STAFF RECOMMENDATION
1801 Woodland Street
September 17, 2014

Application: New construction—infill; Setback determination.
District: Lockeland Springs-East End Neighborhood Conservation Zoning Overlay
Council District: 06
Map and Parcel Number: 08310030800
Applicant: Cathedral Homes
Project Lead: Melissa Baldock, melissa.baldock@nashville.gov

Description of Project: Application is to construct a new duplex infill. The project requires a side setback determination. Base zoning requires that the infill be set ten feet (10') from the 18th Street side property line, but the applicant is proposing to situate the house just six feet (6') from that property line.

FIRST FLOOR PLAN

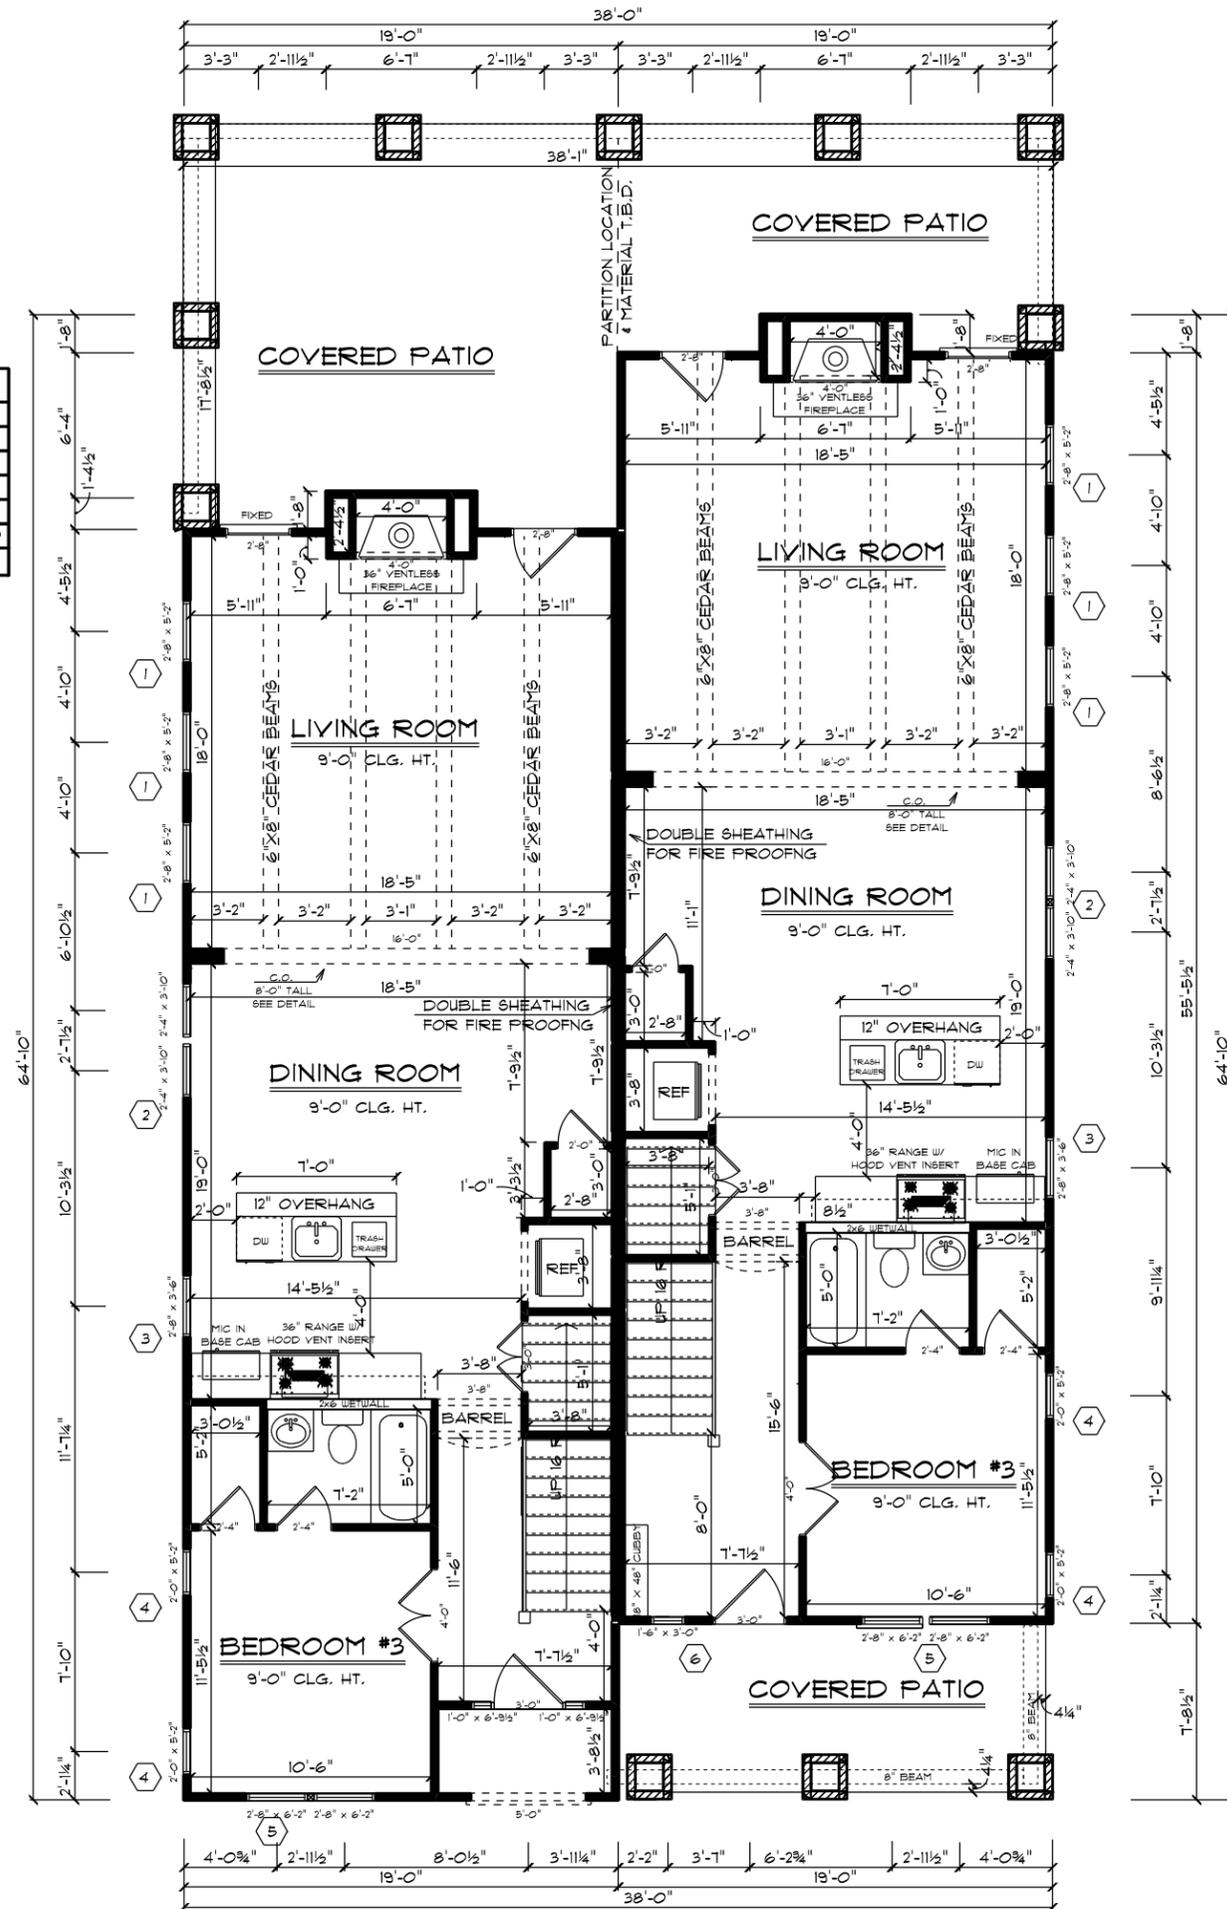
The house does meet the base zoning requirements for setbacks on the interior lot side, where it is six feet (6') from the side property line, and on the rear, where it is more than seventy feet (70') from the rear property line. The front setback for the house will line up with the house to the east at 1803 Woodland Street, which is appropriate. Staff finds that the proposed setback determination of six feet (6') for the 18th Street side property line does not meet Section II.B.3. of the *Lockeland Springs-East End Neighborhood Conservation Zoning Overlay: Handbook and Design Guidelines*. Staff recommends disapproval of the proposed setback determination, and asks that the structure be reduced in width to thirty-five feet (35') and situated on the lot so that it meets the base zoning setbacks.

The infill is proposed to be thirty-eight feet (38') wide and seventy-three feet, two inches (73'2") deep. Staff finds that the house's width does not meet the historic context. In this area, historic one-and-a-half story structures on fifty-foot (50') wide lots range in width from twenty-six to thirty-four feet (26' – 34'), although there is a structure on Forrest Avenue that is thirty-six feet (36') wide. Staff asks that the width of the structure be reduced to thirty-five feet (35') so that it meets both the base zoning setback requirements and the context of historic widths for one-and-a-half story structures on fifty-foot (50') wide lots. With the reduction of the width to thirty-five feet (35'), staff finds that the infill's height and scale meet Sections II.B.1. and II.B.2 of the *Lockeland Springs-East End Neighborhood Conservation Zoning Overlay: Handbook and Design Guidelines*.

1. The width of the house be reduced to thirty-five feet (35'), and the house be shifted on the lot so that it meets the base zoning setbacks and the historic context;
2. The finished floor height be consistent with the finished floor heights of the adjacent historic houses, to be verified by MHZC staff in the field;
3. Staff approve a brick sample, the roof shingle color, the design and material of the front steps and porch floor, the design and material of any front stair or porch railing, and the final details, dimensions and materials of windows and doors prior to purchase and installation;
4. Walkways be added from the street to each of the front entries of the duplex units; and
5. The HVAC units be located behind the house or on the interior lot side of the house, beyond its mid-point.

FRONT ELEVATION

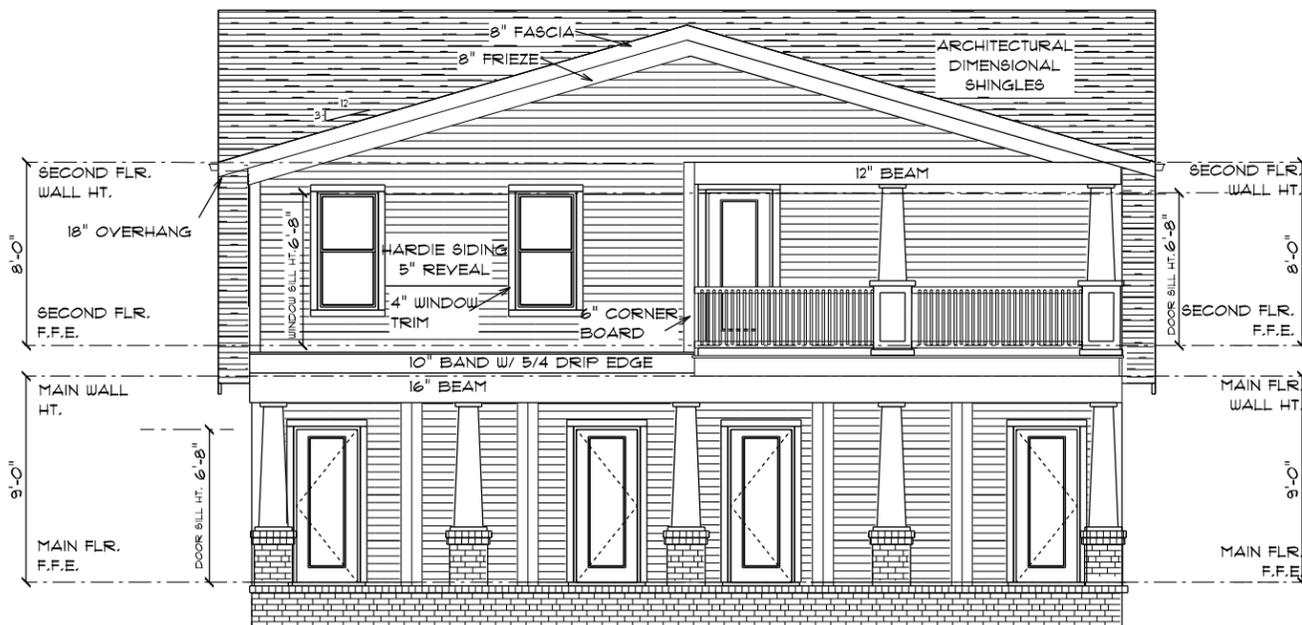
Roof form: The infill's primary roof form is a cross gable. The front gable will have a 16/12 slope, and the side gable will have a 12/12 slope. At the rear will be a lower sloped gable form, with a pitch of 3/12. There is a shed dormer on the front façade with a slope of 5/12. The dormer is appropriately set off of the ridge of the house, and is inset two feet (2') from the wall below. Staff finds that the infill's roof forms are compatible with the historic character of Lockeland Springs and meet Section II.B.5. of the *Lockeland Springs-East End Neighborhood Conservation Zoning Overlay: Handbook and Design Guidelines*.

Orientation: The duplex infill will be oriented so that both units have front entries facing Woodland Street, which is appropriate. The left unit will be situated behind an enclosed stoop, which is four feet (4') deep. While the design guidelines state that porches should be at least six feet (6') deep, it is appropriate for entries behind a stoop to be shallower. The right entry is located behind a partial-width front porch that is approximately eight feet (8') deep. Although the entries to the two units have different configurations, staff finds that they are compatible with each other and they are of equal importance. Staff asks that a condition of approval be that the applicant add walkways leading from the street to each of the entries. In addition, staff asks that the front porch and stoop stairs be added to the drawings. With these conditions, staff finds that the duplex's orientation

LEFT ELEVATION

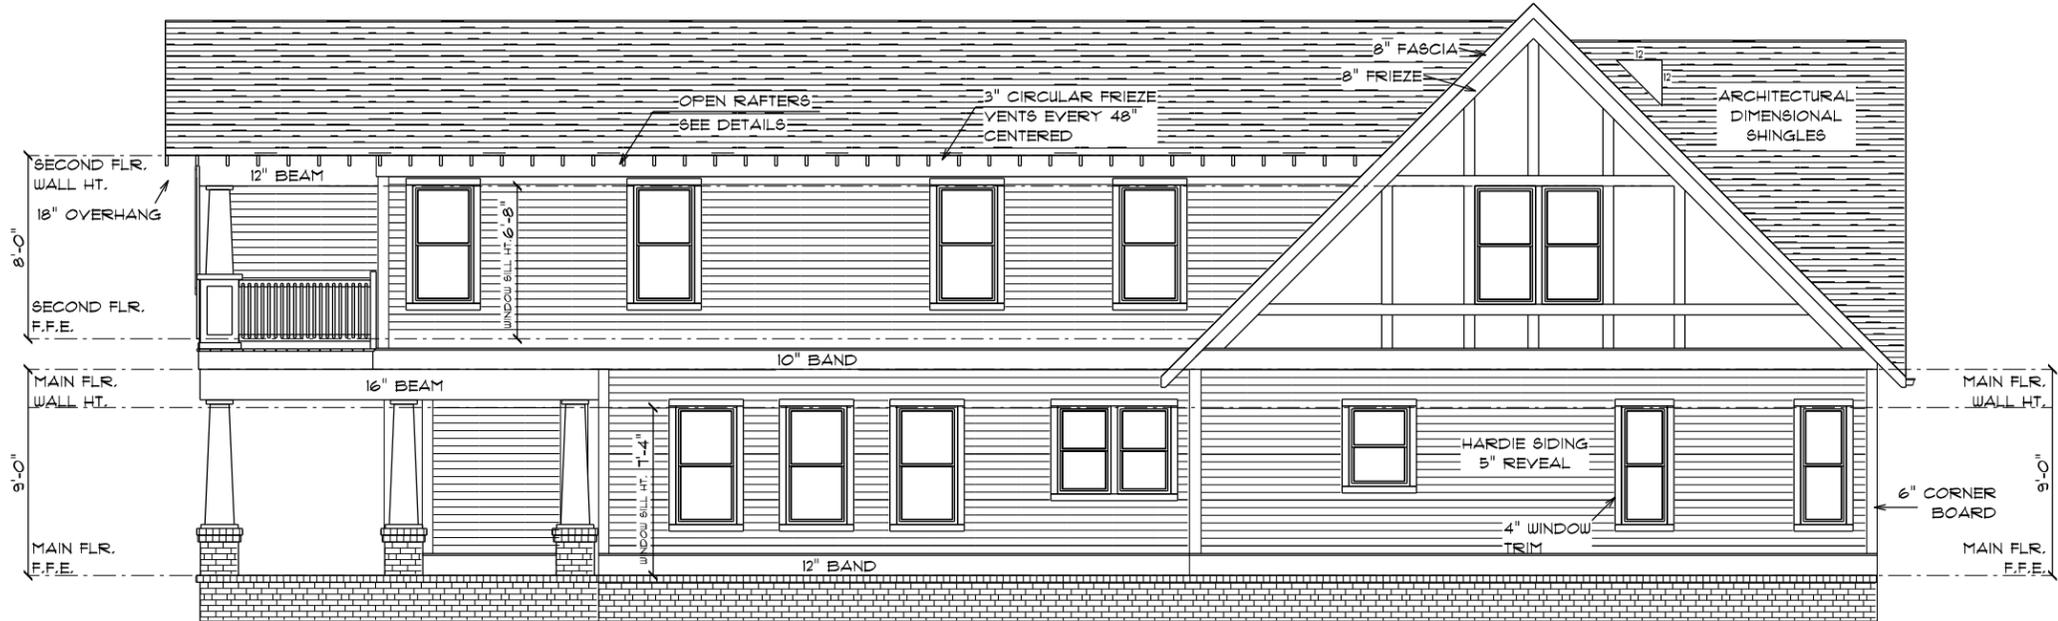
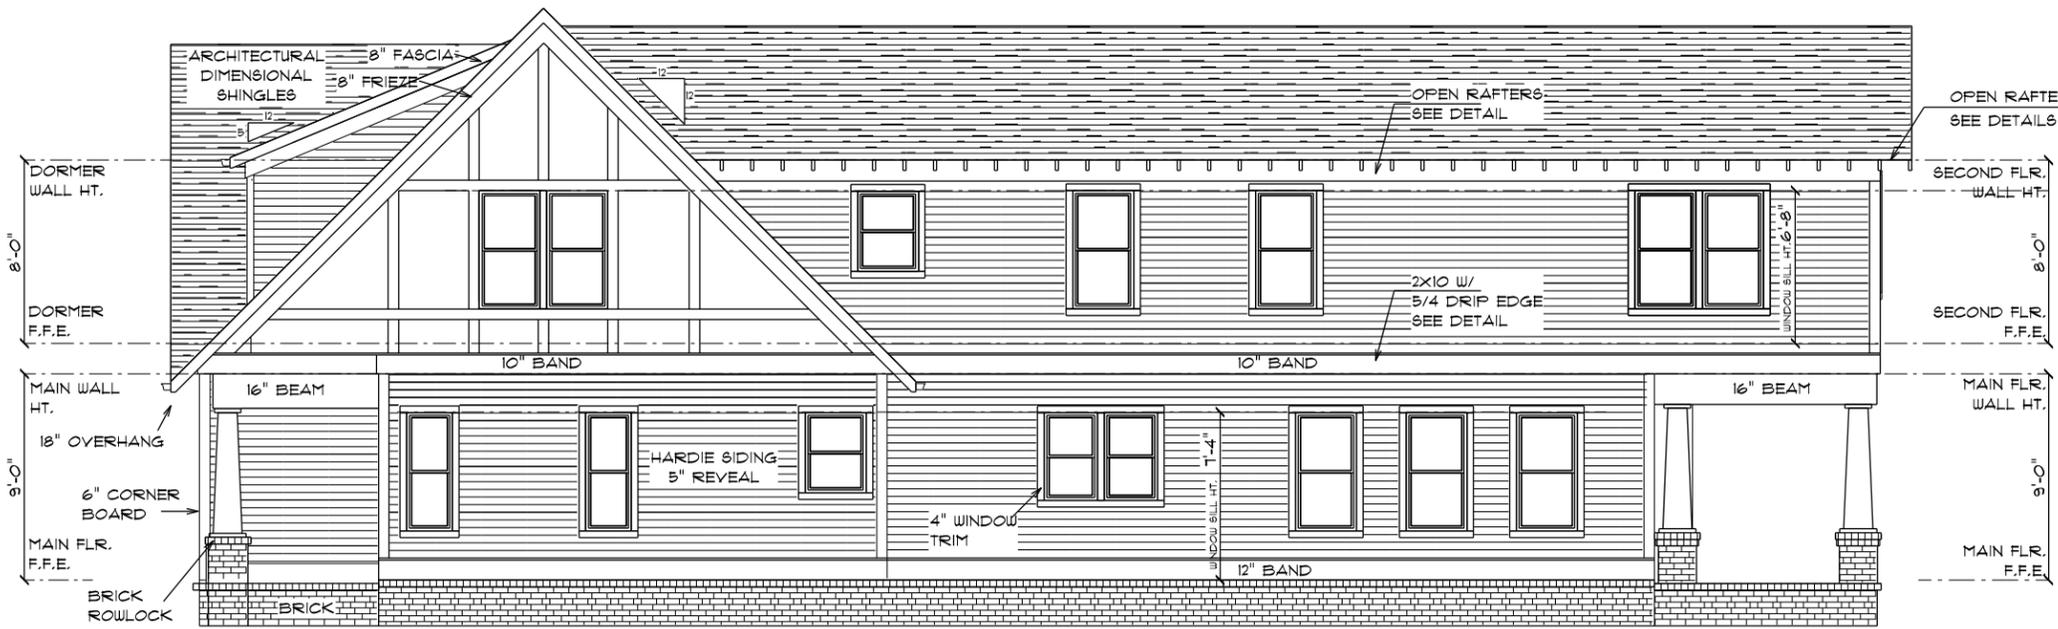
Proportion and Rhythm of Openings: The window openings are generally twice as tall as they are wide, and the windows on the second level are generally not taller than those on the first level, thereby meeting the historic proportion of window openings. There are no large expanses of wall space without a window or door opening. Staff therefore finds that the project's proportion and rhythm of openings meet Section II.B.7. of the *Lockeland Springs-East End Neighborhood Conservation Zoning Overlay: Handbook and Design Guidelines*.
